**DSB SERVICE BULLETIN No. 10-2009 Issue 1**

**Title: Replacement of Thanner OTS-65 Pressure Relief Valves after 10 years on all DSB marine inflatable life saving equipment**

### DSB SERVICE BULLETIN No. 3-2006

## **Marine Liferaft and Slide Products Fitted with Thanner OTS-65 Type Pressure Relief Valve**

**Figure 3 – Installation fo New PRV Assembly into Buoyancy  
(Exploded section shown – not to scale)**

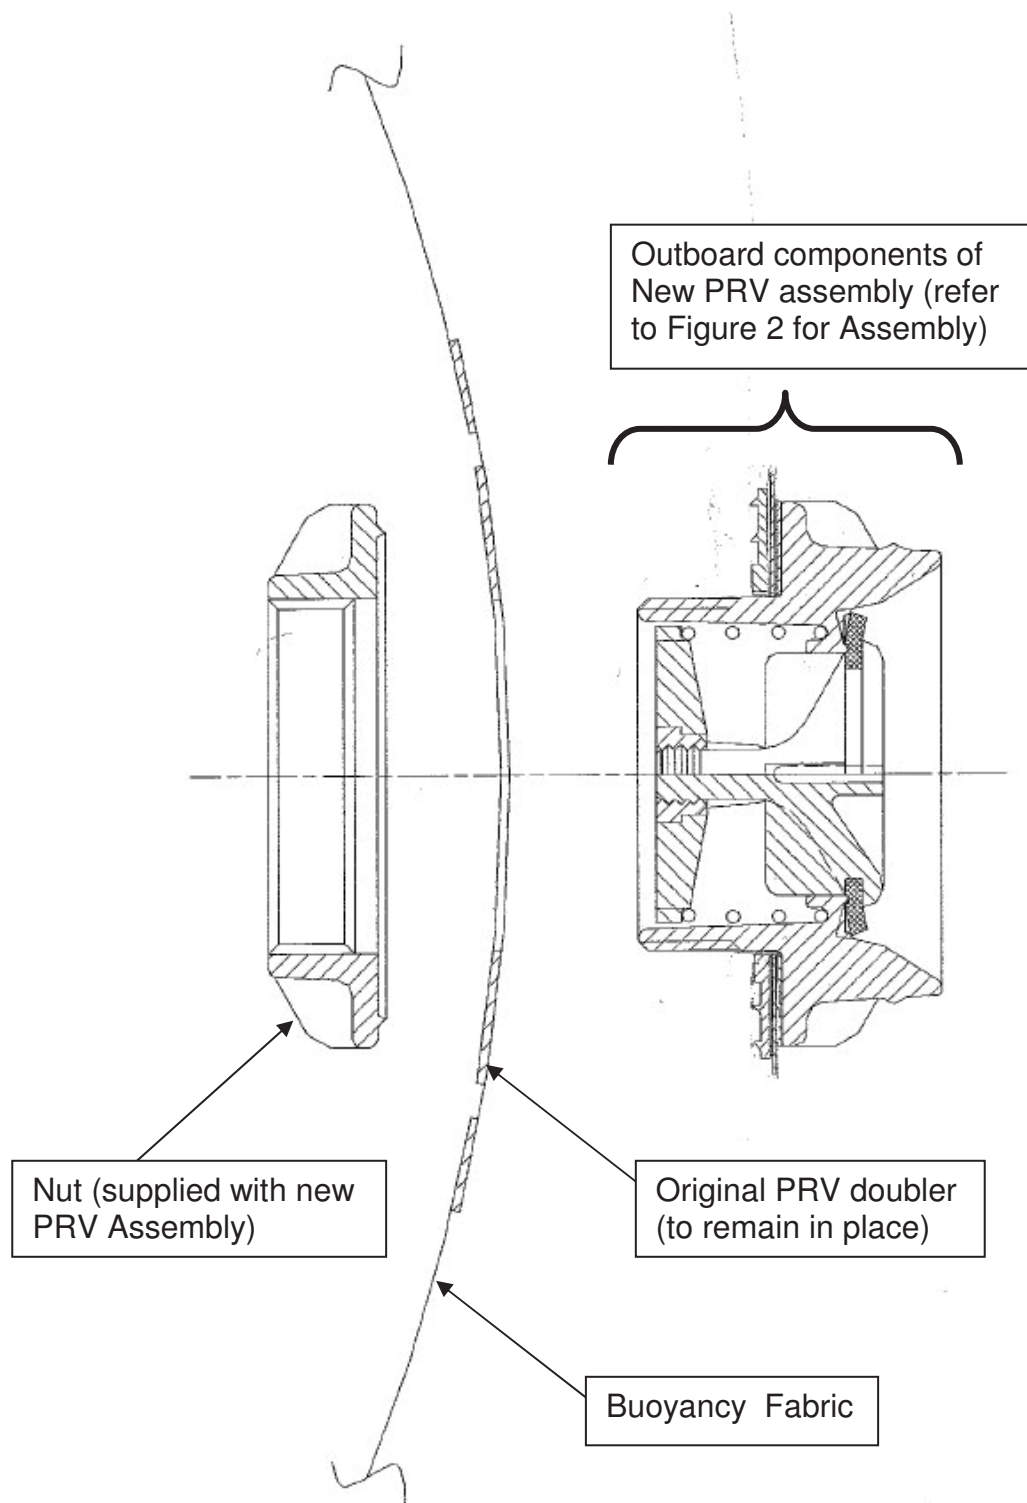
Page 8 of the attached Appendix 1, states that the torque value of 35 Nm (25 Lbf/ft) is to be used. Please note this is to be revised.

- Use the torque wrench – calibrated to 35Nm / 25 lbf-ft **maximum** – mated to the PRV adaptor tool.

**NOTE:** Use the torque wrench – calibrated to 30Nm / 22 Lbf/ft maximum (27Nm / 20 Lbf/ft is recommended) – mated to the PRV adaptor tool.
